3-8-24 TX_KDFW_STAR_BOOVE SEVEN RNAV

V1 IS BEING RETURNED PRE-PRB FOR THE FOLLOWING:

Dallas, Texas
Dallas Fort Worth International Airport (KDFW)
KDFW BOOVE (RNAV) ARRIVAL

ARRIVAL ROUTE DESCRIPTION

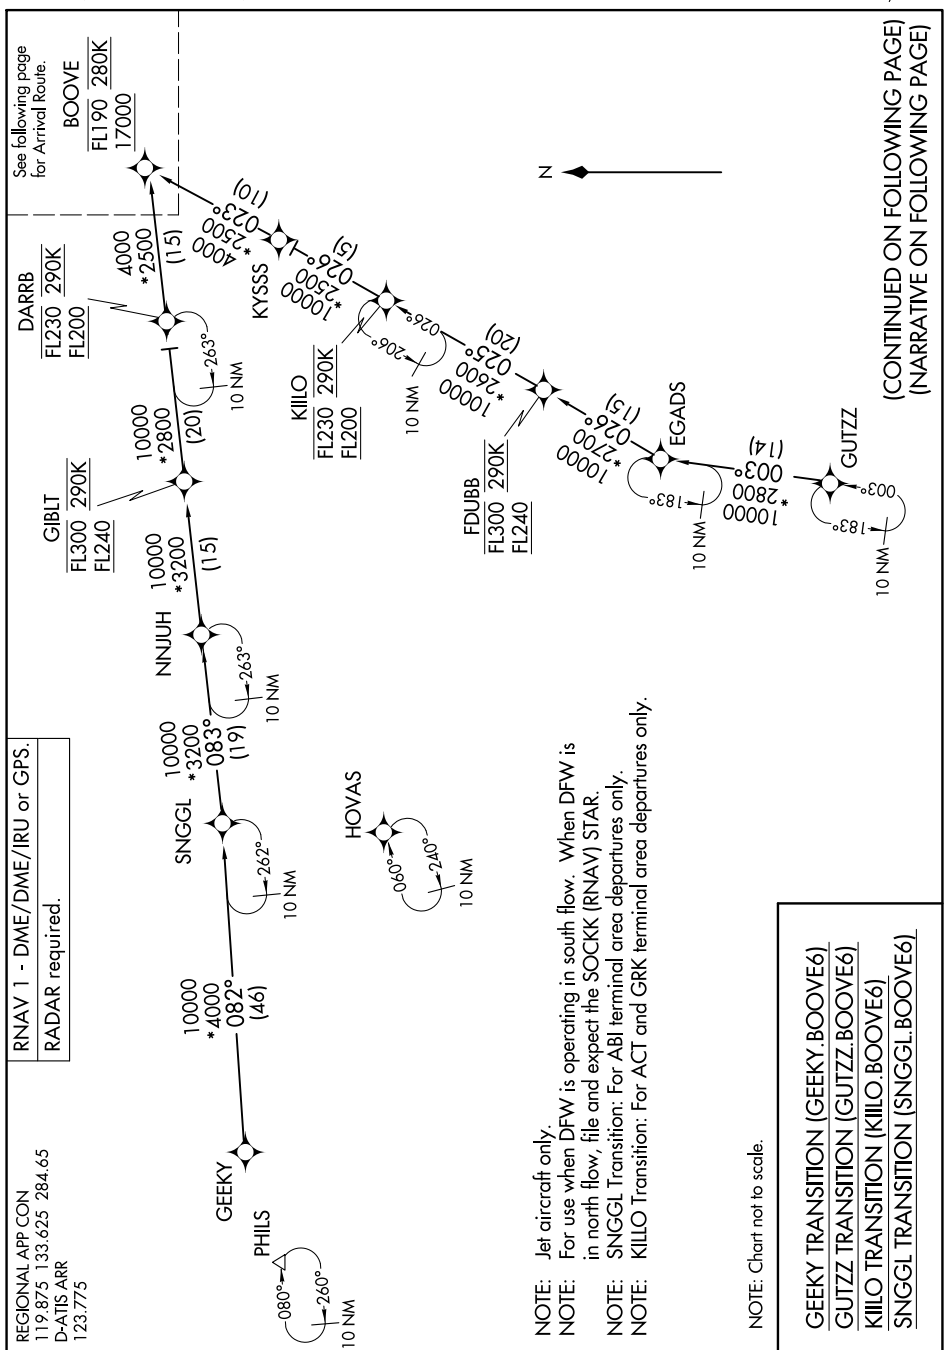
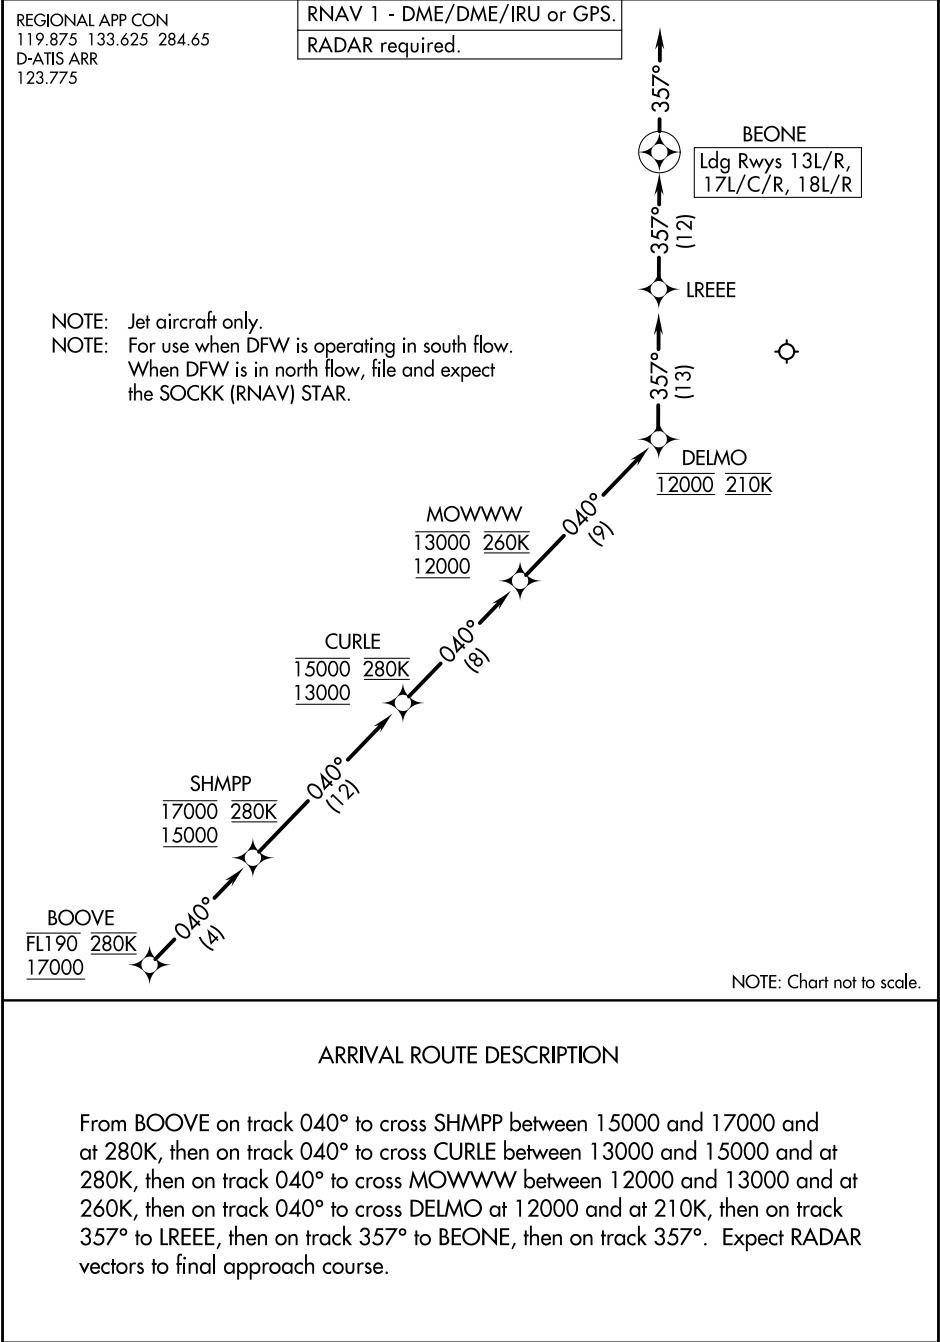
MISSING WAIVER: SPEED RESTRICTION AT MOWWW: SPEED RESTRICTION ASSIGNED TO FIX MOWWW (240) IS LESS THAN THE MINIMUM AIRSPEED RESTRICTION FOR THE FIX (250) REFERENCE 8260.58C TABLE 1-2-2 NOTE 3. PLEASE ENTER A SIMILAR WAIVER AS REQUESTED IN THE SHMPP THREE (RNAV) STAR.

There is an ATC operational requirement for the crossing restriction of 12000B13000 at 240K at MOWWW. The 240K at MOWWW is to ensure aircraft can be safely sequenced at an acceptable, manageable speed. This change was at the request of industry representatives.

Figure 2

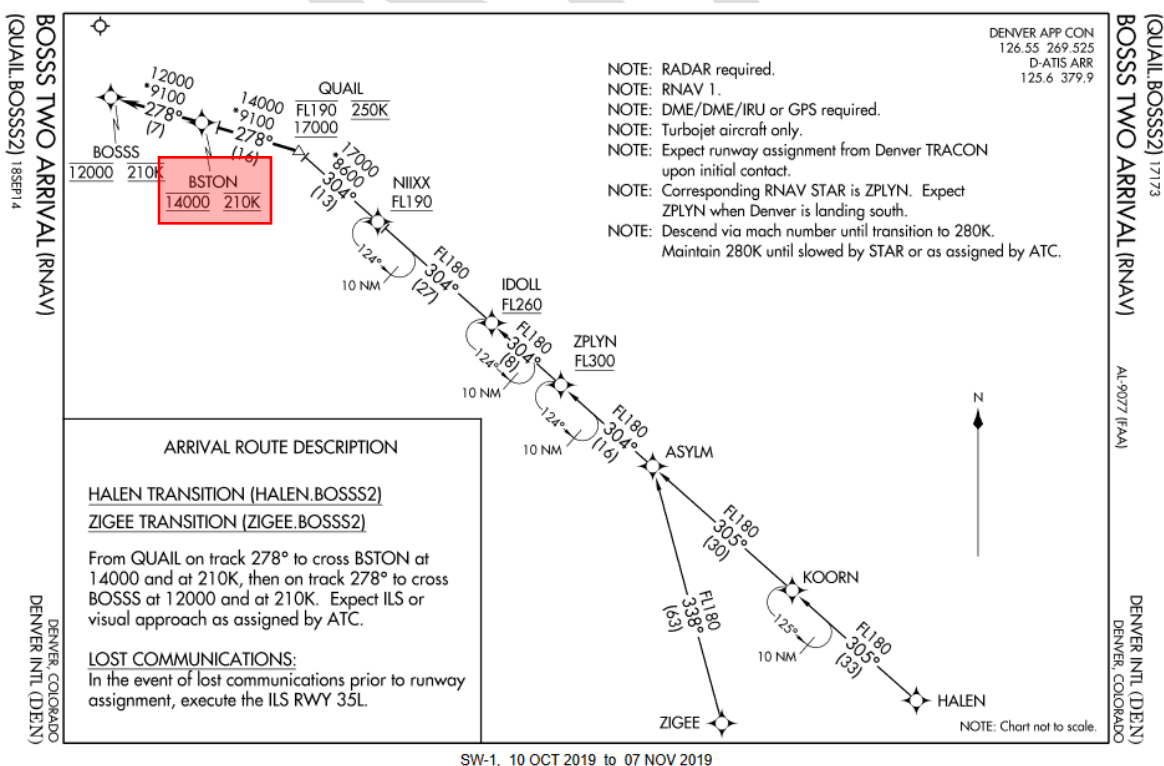
With this in mind, since Order 8260.3D permits use of a minimum airspeed as low as 210 KIAS at and below 14,000 FT MSL, there is no apparent reason why a STAR cannot use a minimum airspeed as low as 210 KIAS at the same altitudes when operationally necessary (see the STAR at Figure 2 below). Updating the STAR procedure design criteria to permit use of a minimum airspeed of 210 KIAS will offer more flexibility in STAR design and better optimize STAR paths, while also eliminating the need to justify a procedure design waiver when the STAR requires an airspeed below 250 KIAS as an operational necessity.

Recommendation: The PARC Navigation Working Group recommends the PARC Steering Group support a change to FAA Order 8260.58A, Table 1-2-2, Note 3, to read; "250 above 14,000 feet MSL".
